Application for Licence Amendment

Licence Number	L4247/1991/13
Licence Holder	Talison Lithium Australia Pty Ltd
ACN	139 401 308
File Number	2012/0071641
Premises	Talison Lithium Mine Maranup Ford Road GREENBUSHES WA 6254 Legal description – Mining tenements M01/3, M01/6, M01/7, M01/8, M01/9, M1/16, L70/232 and L70/244 and General-purpose lease G01/1 and G01/2 As defined by the Premises maps in Schedule 1 and coordinates in Schedule 3 of the revised Licence
Date of Report	1 August 2024
Decision	Revised licence granted

This Amendment Report documents the assessment of potential risks to the environment and public health from proposed changes to the emissions and discharges during the operation of the Premises. As a result of this assessment, Revised Licence L4247/1991/13 has been granted.

Figure 2: Tailings Storage Facility 4 Cell 1a (RL 1261 m)

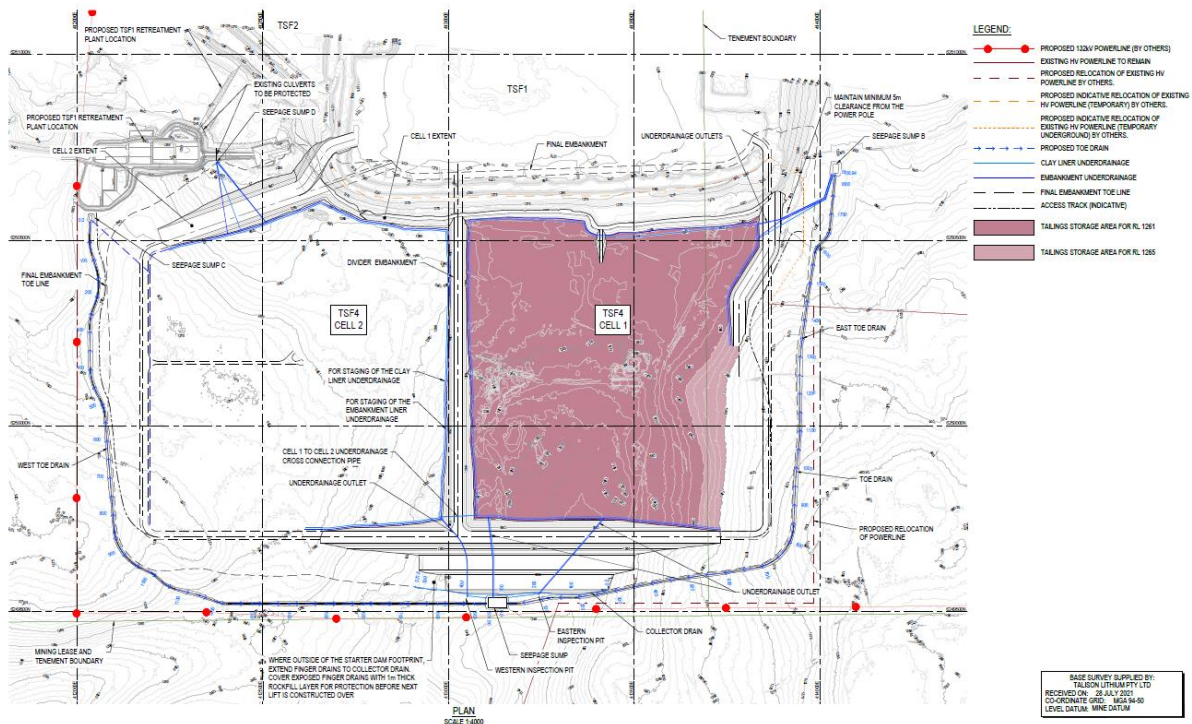
The CCIR for the TSF4 Cell 1a was submitted to the department on 1 December 2023 (Figure 2). During the internal assessment of the report, the department identified several deviations to the constructed design as opposed to what was previously approved in the works approval. The following deviations were identified:

- Embankment between TSF1 and TSF4. The works approval design required a minimum 7.5 m wide clay lining on the outside of the TSF1 embankment, below the construction for TSF4 embankment. Instead, a modified design was built with this structure primarily constructed from mine waste material, with a thin clay lining facing TSF4;

The Department considered in its assessment that these deviations may have the potential to change the risk of the facility with the following concerns:

As part of the compliance assessment, the department requested further information from the Licence Holder to provide explanation for these identified deviations. The Licence Holder provided additional information on 22 December 2023 and 15 January 2024, with the following comments:

Figure 6: Cumulative flow leach testing results (LEAF 1314) - logarithmic scale of mg/L

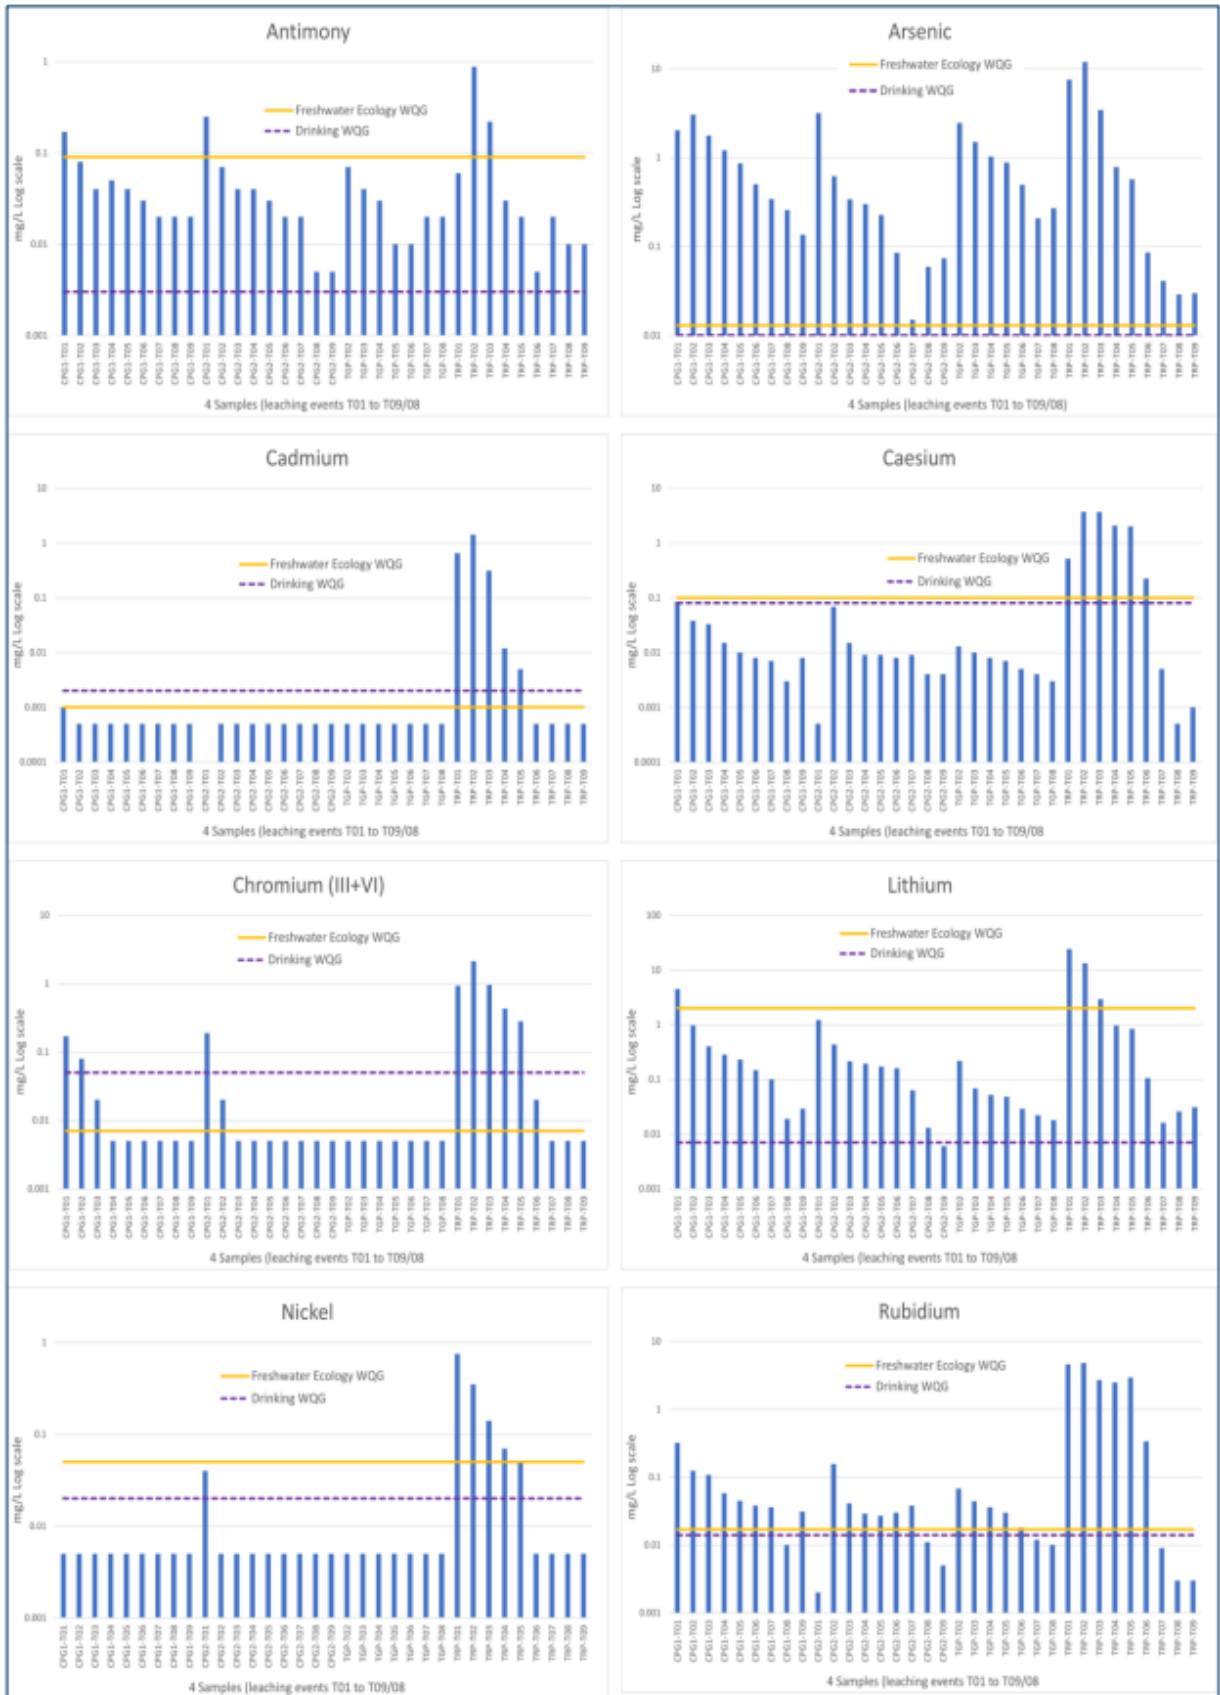
In reviewing the submitted leach test results, the department considers that the leach testing of only three grab samples of tailings material is likely to be insufficient to adequately characterise the leaching behaviour of tailings material. Expert technical advice received has recommended that additional sampling for leach testing is likely to be required to better understand the likely contaminants associated with the tailings and short-term leach testing should be carried over the operational life of the facility to provide information in the development of mine closure strategies. The department notes that since the submission of this application, the Licence Holder has conducted long-term leach testing. The results and department’s assessment of the results are detailed under the current works approval W6901/2024/1.

Figure 7: Hydrogeological cross section for TSF4

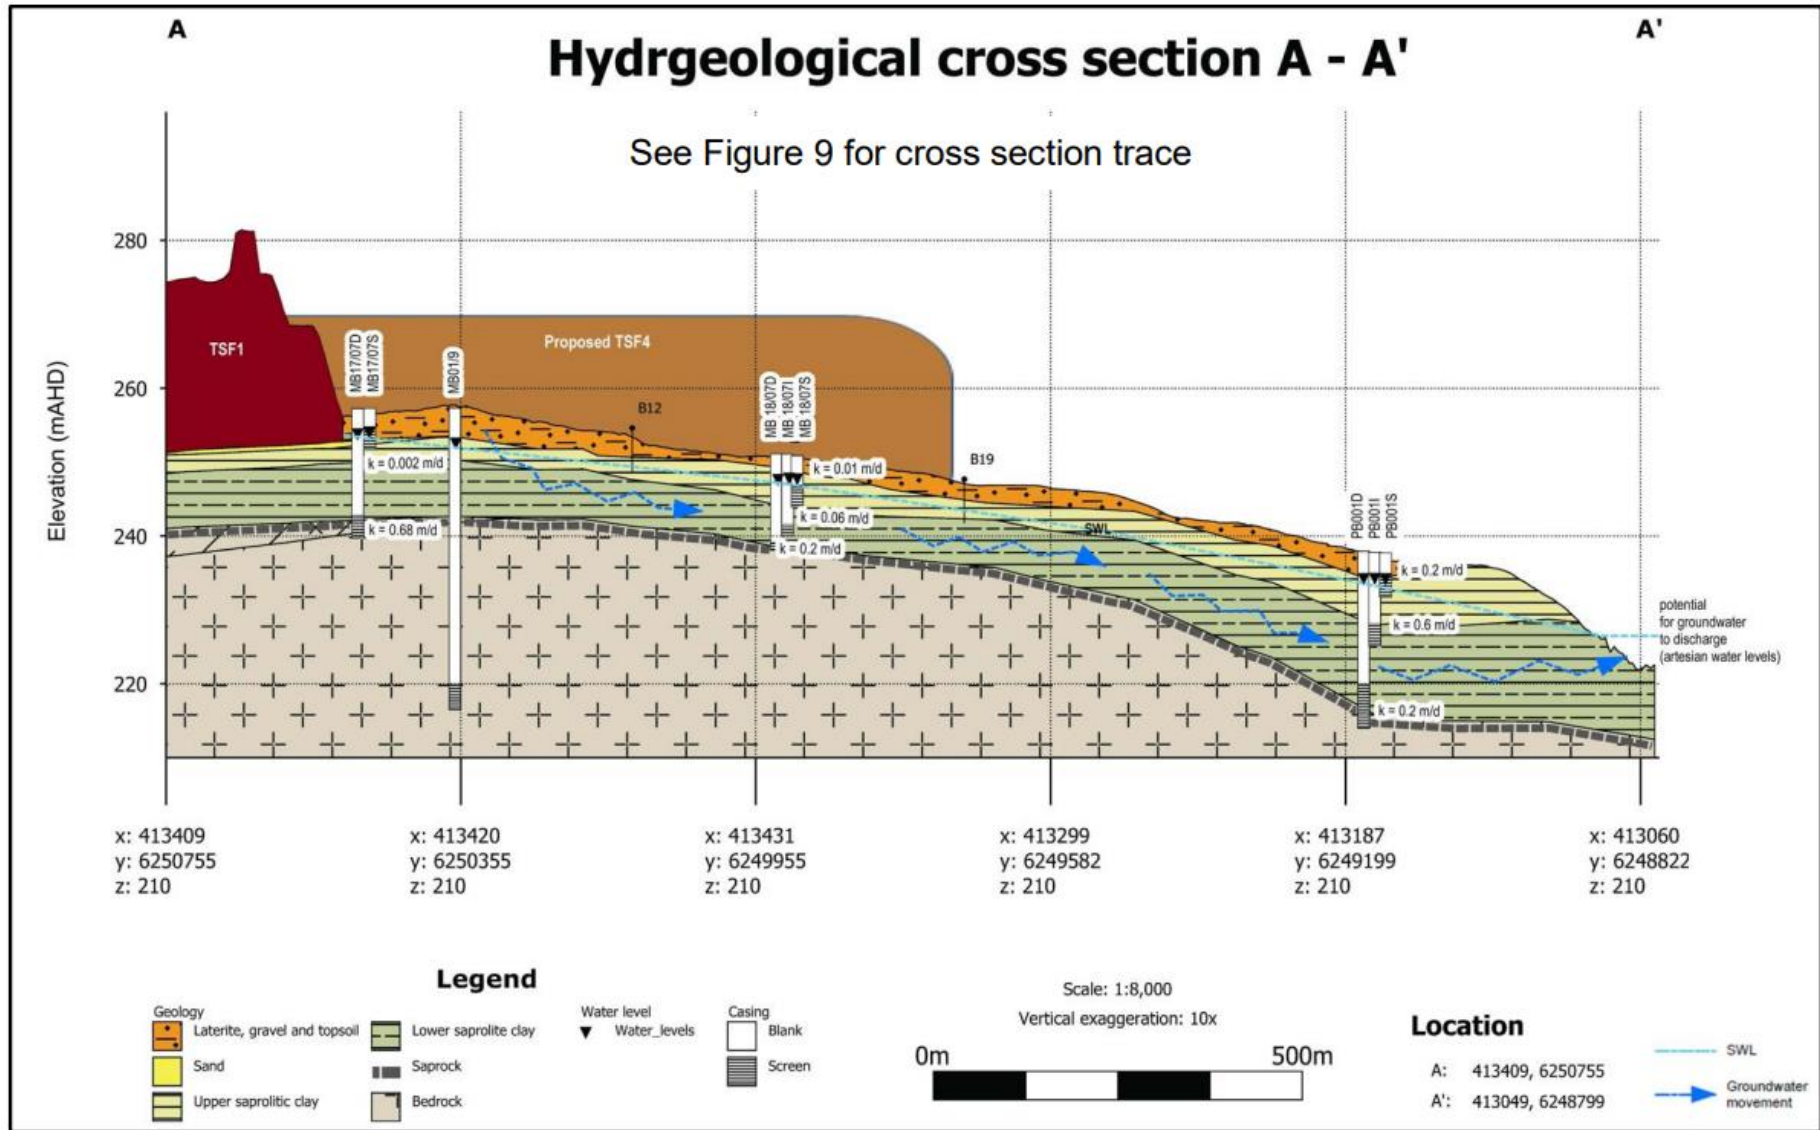
Although the use of slug tests to measure hydraulic conductivity is a useful technique in some situations, this method of testing only provides an estimate of hydraulic conductivity of regolith within a few metres of each tested borehole and cannot provide estimates of this parameter at larger scales. For this reason, the estimates of hydraulic conductivity of saprolite and the saprock aquifer may not be correct at a broader scale in the subsurface near TSF4 – they are also not consistent with measurements made in these materials in the region by some other studies. Other studies on groundwater recharge to aquifers in granitic weathering profiles have indicated that the only effective way of identifying the effects of recharge through preferred pathways in saprolite is by using regionally extensive water-balance assessment methods (i.e. as referred to in Cuthbert and Tindimugaya (2010) and Grigg and Kinal (2020)).

Internal technical advice suggests that although a hydrogeological model for the area near TSF4 was provided, the presented schematic cross section did not provide sufficient information regarding the spatial distribution of potential bedrock fractures and palaeodrainages that could be significant groundwater pathways. It is considered that additional work such as a detailed geological map of basement rocks and their structural characteristics in the area, and a ground-based geophysical survey using electrical and/or electromagnetic techniques on transects around the toe of TSF4 would identify the presence of conductive zones in the bedrock. These conductive anomalies in the bedrock would provide suitable target for the construction of additional monitoring bores.

Notwithstanding this, the delegated officer considers that the proposed monitoring bores are sufficient in the interim, and that the addition of reportable criteria (derived from the Licence Holder's proposed SSWQG) will provide comparable values to the data detected in these bores during operation.

Figure 15: Design features (including underdrainage work) for the Emergency Dump Pond

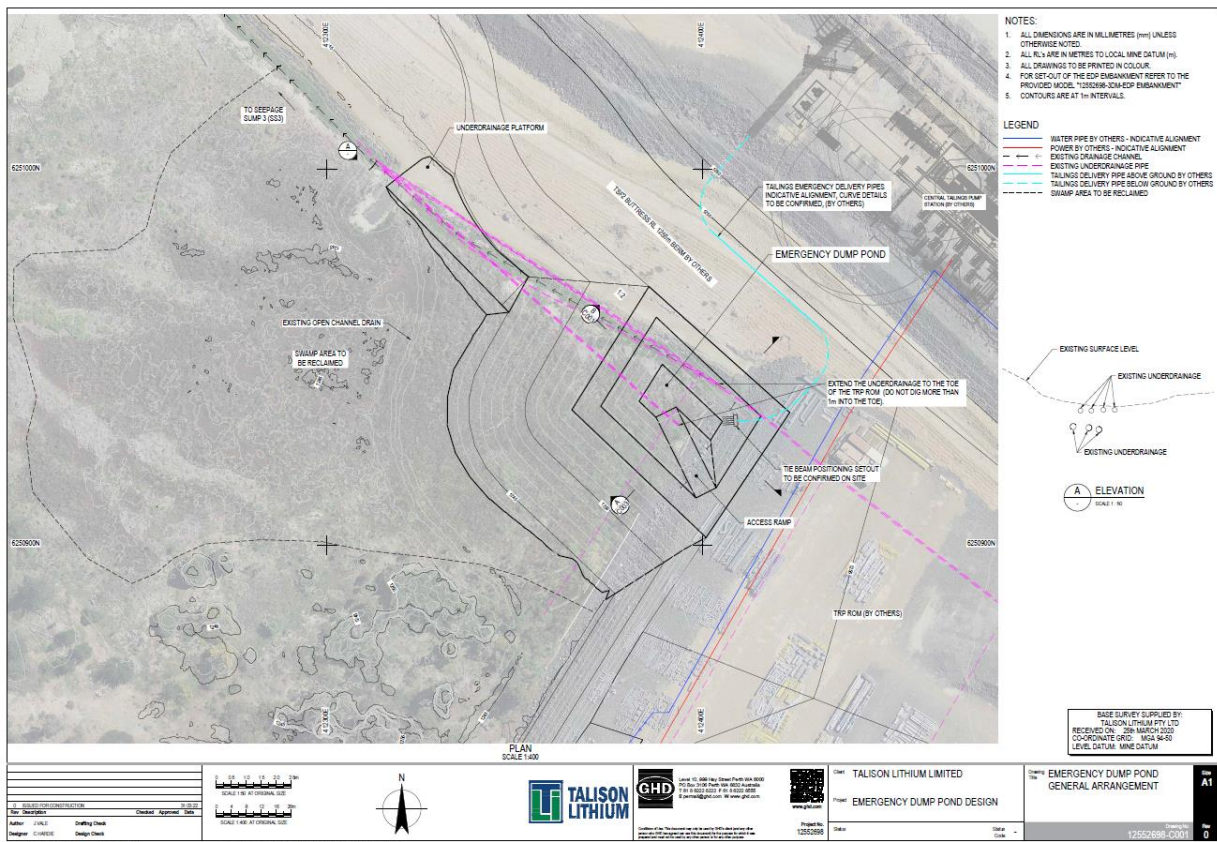
The consequence rating for the contamination due to seepage is considered **minor** as the swampland area is directly adjacent to the buttress of the TSF2 and the installed EDP and is likely to be degraded. Although the distance to the water table in the area of the EDP is approximately 7 to 9 metres, the swampland is likely connected to the groundwater at this location, and therefore the likelihood has been given a rating of **possible**.
